**Planning Commission Agenda
June 15, 2021 – 6:00 p.m.
233 South Main Street, Monroe, Ohio**

TO: Members of the Monroe Planning Commission
FROM: Kevin Chesar
Director of Development

DATE: June 15, 2021
RE: Information Packet for June 15, 2021 Planning Commission Meeting at 6:00 p.m.

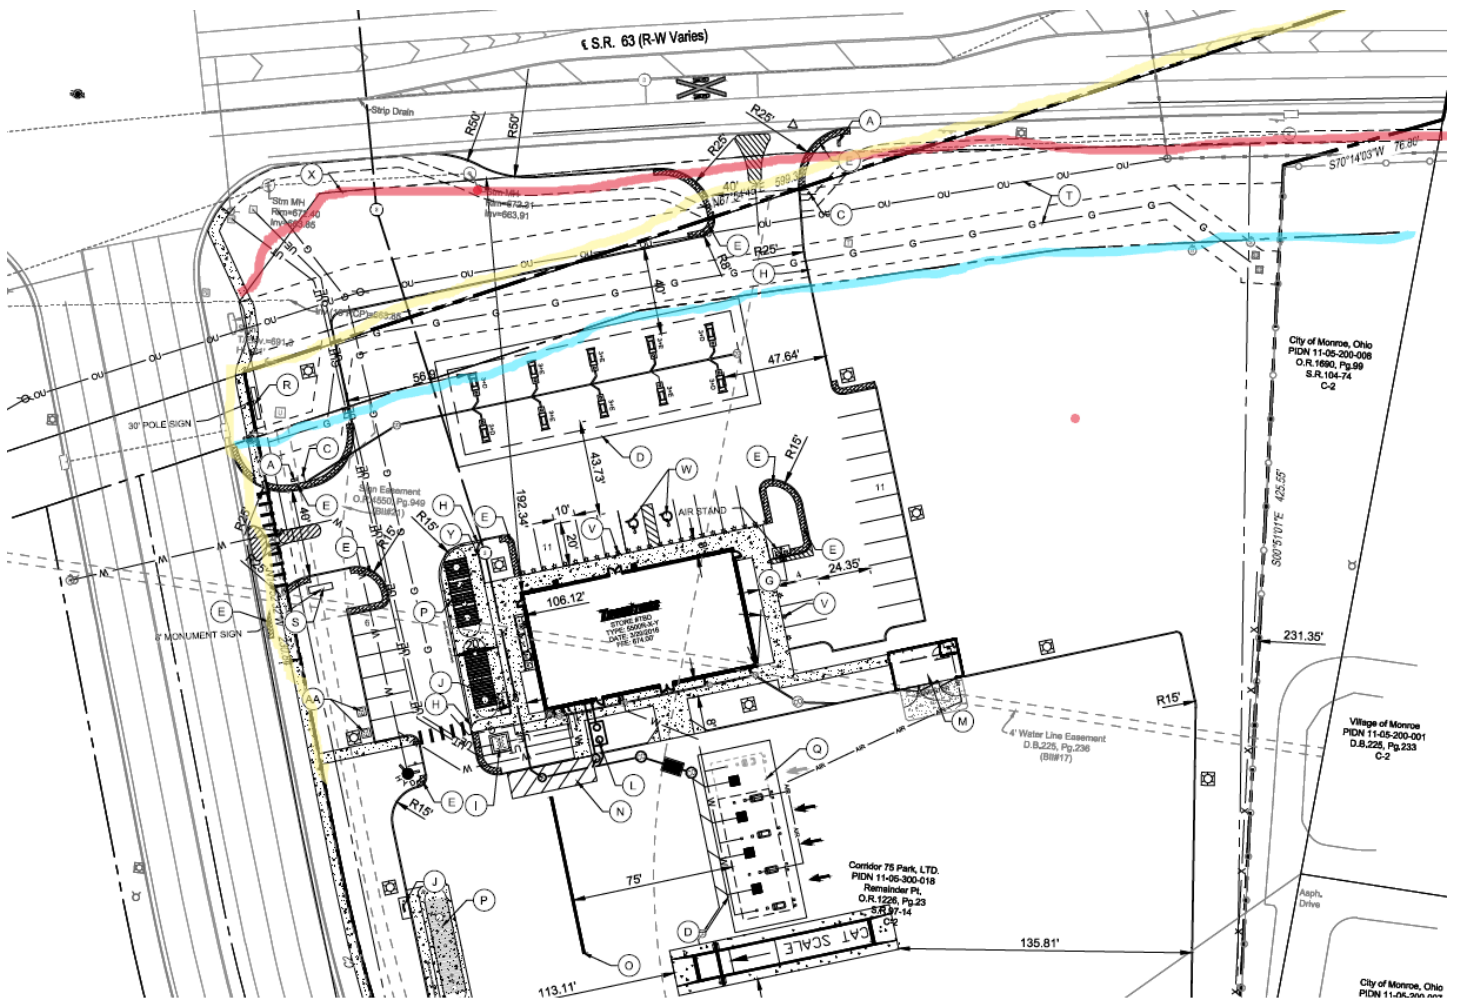
Based on the abovementioned code requirements, the site plan needs to be updated to remove or appropriately reflect area, sign type, and locations for all signs.

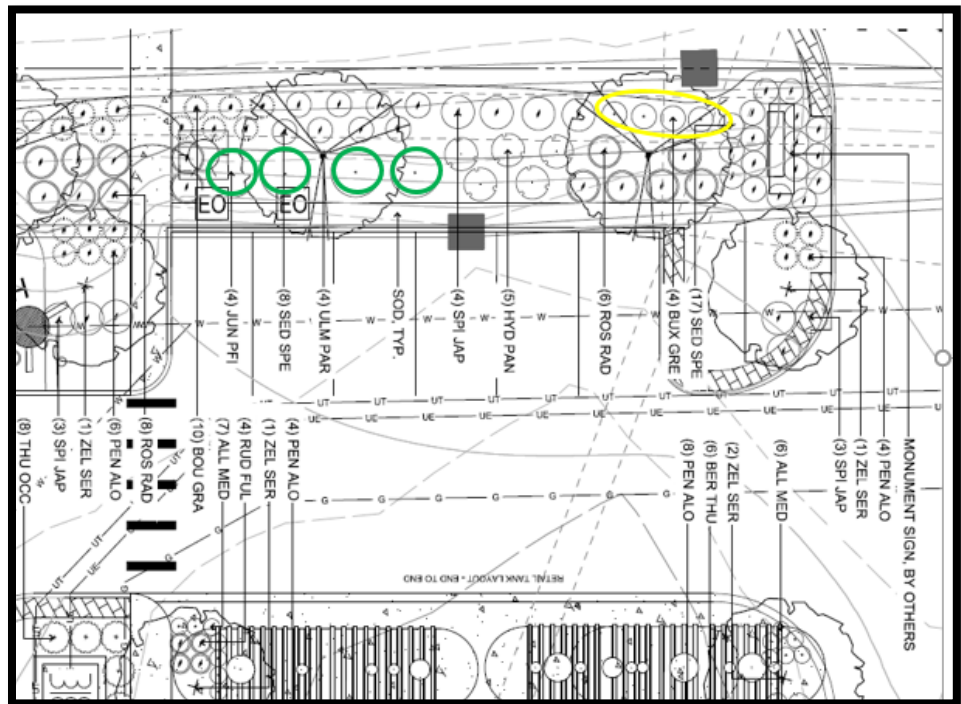
Based on the abovementioned code requirements, Staff recommends denial of the site plan.

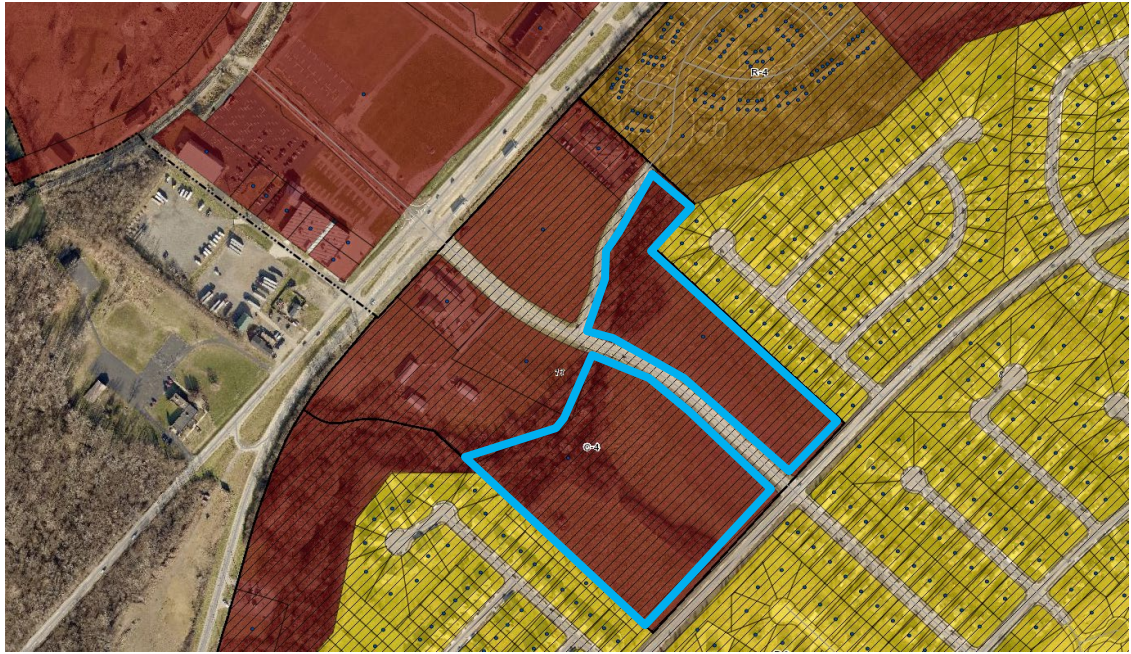
- The applicant will revise plans to locate and screen the dumpster to meet code.
- The applicant will revise the landscape plan to include the two required canopy trees in the landscape island at the southeastern interior parking row as outlined in the report.
- The applicant will revise plans to show the access drive as a solid surface, either concrete or asphalt.
- As a reminder, minimum size and species requirements related to landscaping must be met.
- As a reminder, if groundmounted or rooftop equipment becomes necessary in the future, screening will be required.
- All other Staff comments to be met and any future Engineering review requirements.
- Architectural requirements be approved as proposed to recognize compatibility with the structure noting that it is not on a major corridor and at the end of a cul-de-sac.
- A GIS compatible file of finalized plans be submitted.
